Dolby Laboratories Inc

Field Bulletin 227

CP500 Loss of Sound During Power-Up Cat. No. 675A or Cat. No. 662A

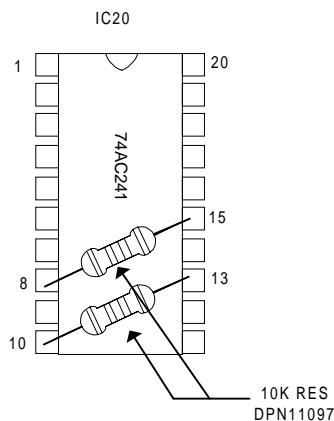
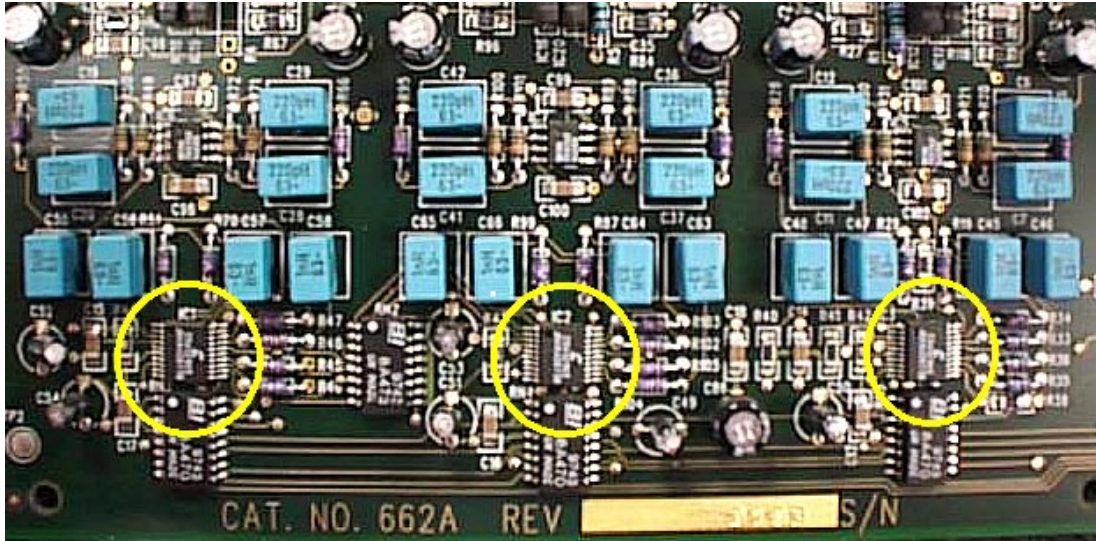
1. Remove the Cat. No. 675A board in slot J14 and add a resistor to ground on each of the two noisy clock lines.

Using the photograph below as a reference locate IC20 on the Cat. No. 675A board.

Carefully solder one 10k ohm 5% 0.25W resistor between pins 13 and 10 of IC20 and another 10k ohm 5% 0.25W resistor between pins 15 and 8 as shown on the drawing and photograph below.

Note: R63 and C125 to the left of IC20 may or may not be installed depending upon the age of the board.

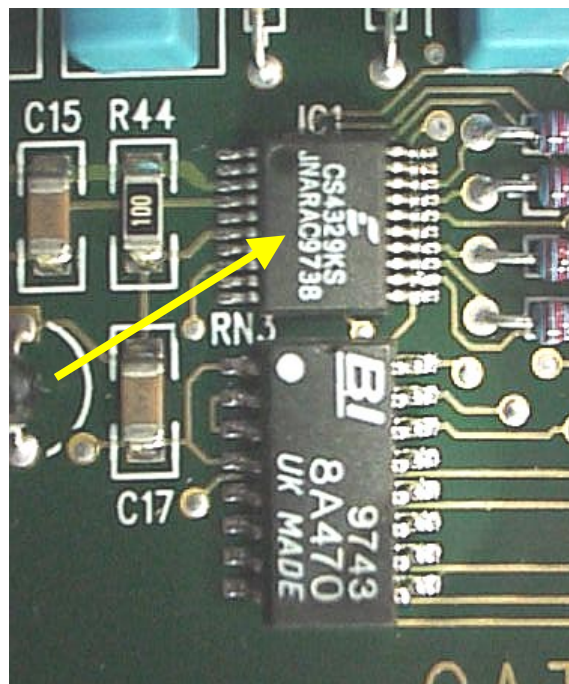
2. Remove the Cat. No. 662A board from slot J11. Using the photograph below as a reference locate the D-to-A converters IC1, IC2 and IC3.

Check the marking on each of the three ICs to determine the manufacturer's revision code.

The revision code is included on the second line of text on the body of the IC and is the last letter in the sequence before the numbered date code. The example above shows revision code "C" in the line JNARACC9738.

If any of the ICs show revision code C, contact Dolby Laboratories for a replacement Cat. No. 662A card.
